# UNITED STATES PATENT AND TRADEMARK OFFICE

APPLICATION NO.	FILING DATE	FIRST NAMED INVENTOR	ATTORNEY DOCKET NO.	CONFIRMATION NO.
10/578,001	05/03/2006	Shunpei Yamazaki	740756-2967	3719
22204	7590	05/27/2009		
NIXON PEABODY, LLP 401 9TH STREET, NW SUITE 900 WASHINGTON, DC 20004-2128			EXAMINER KARIMY, MOHAMMAD TIMOR	
			ART UNIT 2894	PAPER NUMBER
			MAIL DATE 05/27/2009	DELIVERY MODE PAPER

<b>Office Action Summary</b>	<b>Application No.</b> 10/578,001	<b>Applicant(s)</b> YAMAZAKI ET AL.	
	<b>Examiner</b> MOHAMMAD Timor KARIMY	<b>Art Unit</b> 2894

## DETAILED ACTION

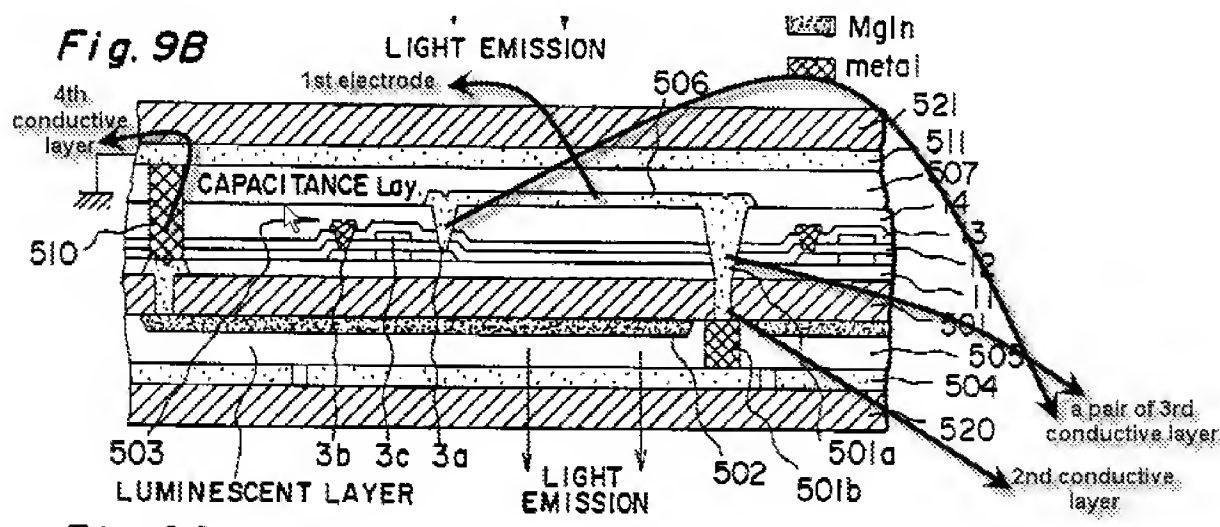
With respect to claim 8, Nishio discloses in figures 1-10, a display device comprising:

- a first insulating layer 505 having a first opening (Fig. 9C);
- a first conductive layer 501b fitted in the first opening (Fig. 9C);
- a second conductive layer (lower portions of 501a in layer 504) on and in contact with the first insulating layer 505 and the first conductive layer 501a (Fig. 9C);

- a semiconductor layer (3a-3c) over the second conductive layer with a gate insulating film 12 therebetween (Fig. 9C);
- a pair of third conductive layer (see Fig. 9C below) over the semiconductor layer;

- a first electrode (layer 506 in layer 507) over one of the pair of third conductive layer (Fig. 9C);
- a second insulating layer 14 having a second opening over the third conductive layer; and

- a fourth conductive layer (portions of 510 in layer 14) fitted in the second opening (Fig. 9C);
- an electroluminescent layer 507 over the first electrode; and

- a second electrode 511 over the electroluminescent layer,

wherein **the first conductive 501a** is thicker than the second conductive layer in a vertical direction (see Fig. 9C below), and

wherein the surface of the insulating layer 505 and the first conductive layer is planarized (Fig. 9B), and

wherein the fourth conductive layer is thicker than the pair of third conductive layer (see Fig. 9B below).

It is worth mentioning that the limitation "**wherein each of the second conductive layer and the third conductive layer is formed by a droplet discharge method using a conductive material**" is a product by process limitation and it does not result to a structurally distinguishable product over the prior art.
